Petition Number: #2022-096

From: Jake Carpenter, PE Reviewer: Travis Miller

General Review Information

Reference (CLDSM standard detail U-05A and U-03A) for street typical.

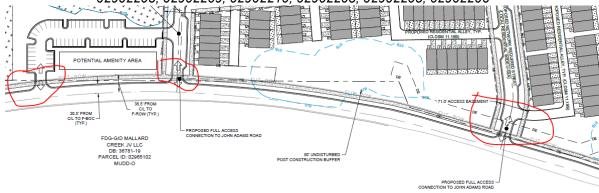
6. The proposed dwelling units exceeds 12 per acre. Per Chapter 20 Subdivision ordinance, site plan and conditional note(s) revisions are needed to commit to construct an 8-foot planting strip, and 8-foot sidewalk along John Adams Road, Galloway Road and all internal network required public Streets. The wider sidewalk also meets the Charlotte WALKS Policy.

Clarifying comment 6.21.2023: Label and dimension 8 foot planting strip and 8 food sidewalk on all internal public streets.
